Access Compliance Report

Public Rights-of-Way

(Curb Ramps)

Intersection ID: 3448	Main Street: W W T HARRIS BV TO I-77 RA SB	Access Street: I-77 TO W W T HARRIS BV RA SB	Location: NW
ADA ID: 6403FA12CB2B	Ramp Type: Para	Initial Pass/Fail: Pass	Overall Compliance: No
Severity Score: 5.25			
Codes/Mitigation Info/Possible Solution		Field Measurements/Component Compliance

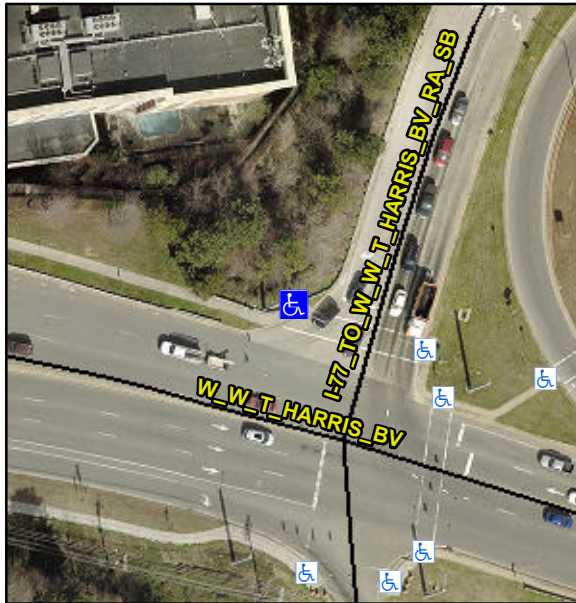
**Remove & Replace Entire Ramp.
Remove & Replace Gutter.**

R304.5.3, R304.2.1, R302.7, R304.5.4

Compliance	Description	Data	Compliance	Description	Data
N/A	Ramp Length LT (in)	67.0	N/A	Ramp Length RT (in)	64.0
Yes	Ramp Width LT (in)	62.0	Yes	Ramp Width RT (in)	62.0
Yes	Ramp Slope LT (%)	7.1	Yes	Ramp Slope RT (%)	7.1
No	Ramp XSlope LT (%)	2.5	No	Ramp XSlope RT (%)	3.1
Yes	Landing Length (in)	66.0	Yes	DWS Provided?	Yes
No	Landing Width (in)	47.0	Yes	DWS Contrast?	Yes
Yes	Landing Slope (%)	0.2	Yes	DWS Length (in)	25.5
Yes	Landing X Slope (%)	1.8	Yes	DWS Full Width?	Yes
N/A	Landing Curb? (Y/N)	No	Yes	DWS Offset (in)	1.5
N/A	Shared Landing?	No			
No	Gutter Ponding?	Yes	No	Gutter Slope (%)	5.1
Yes	Gutter Lip Ht (in)	0.0	Yes	Gutter X Slope (%)	0.1
N/A	Painted X Walk1?	Yes	N/A	Painted X Walk2?	N/A
	X Walk 1 Direction	To SE		X Walk 2 Direction	N/A
N/A	X Walk 1 Width (in)	136.0	N/A	X Walk 2 Width (in)	N/A
	X Walk 1 Slope (%)	1.0		X Walk 2 Slope (%)	N/A
	X Walk 1 X Slope (%)	0.7		X Walk 2 X Slope (%)	N/A
Yes	Ramp inside XWalk1?	Yes	N/A	Ramp inside XWalk2?	N/A
